Intel® StrongARM* SA-1110 Microprocessor

Specification Update

December 2001

Order Number: 278259-023

Figure 10-1. General Memory Interface Configuration

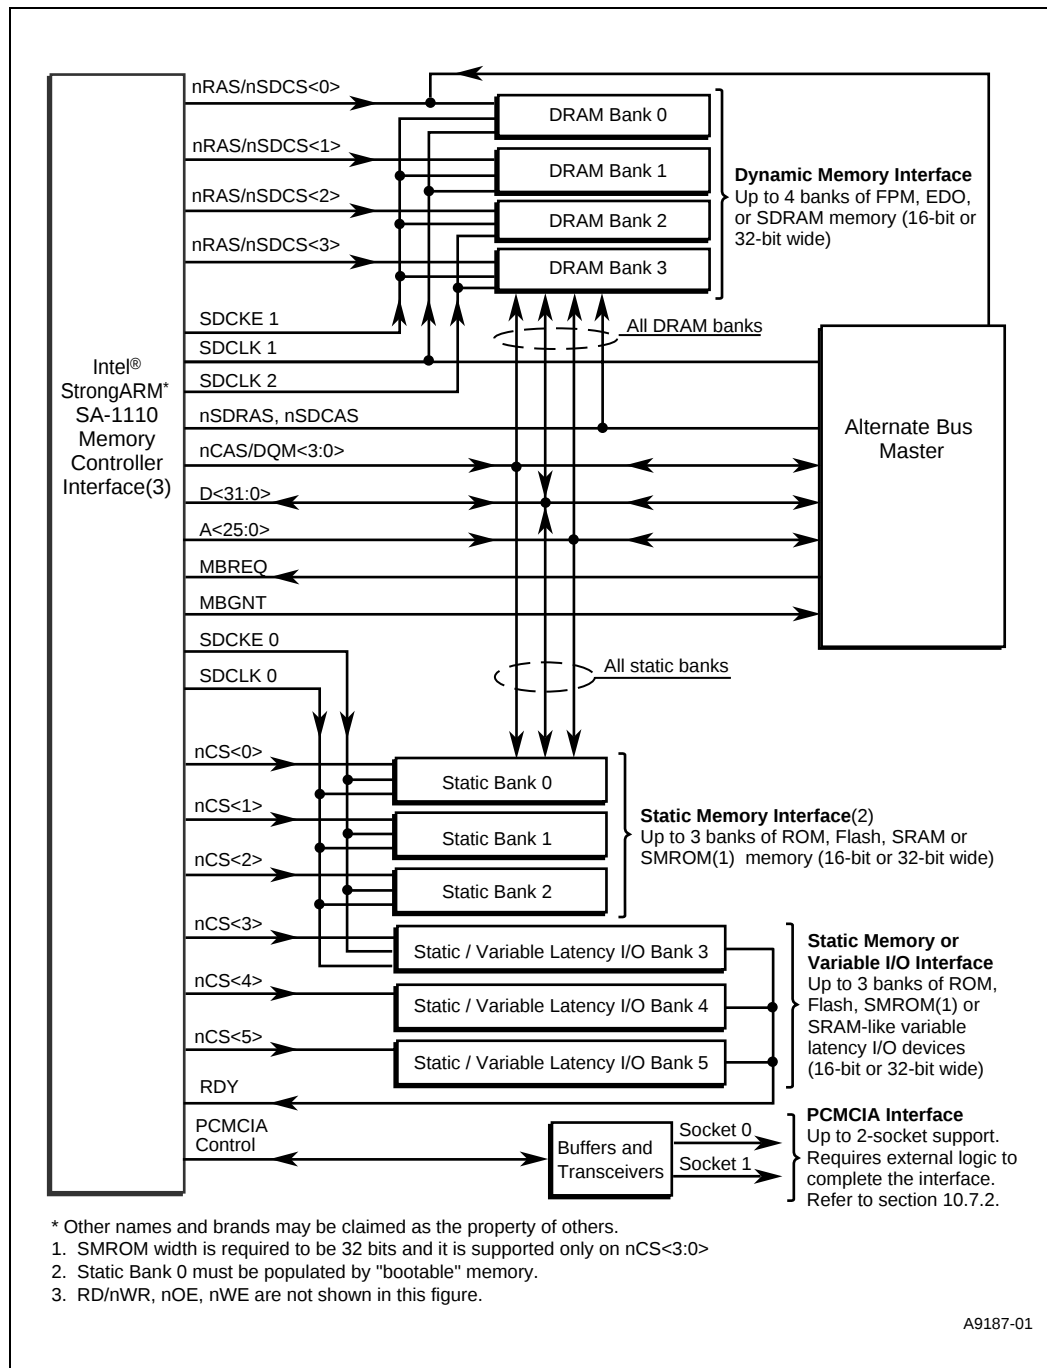
4. Memory and PC-Card Control Module: Section 10

Changed Figure 10-1:
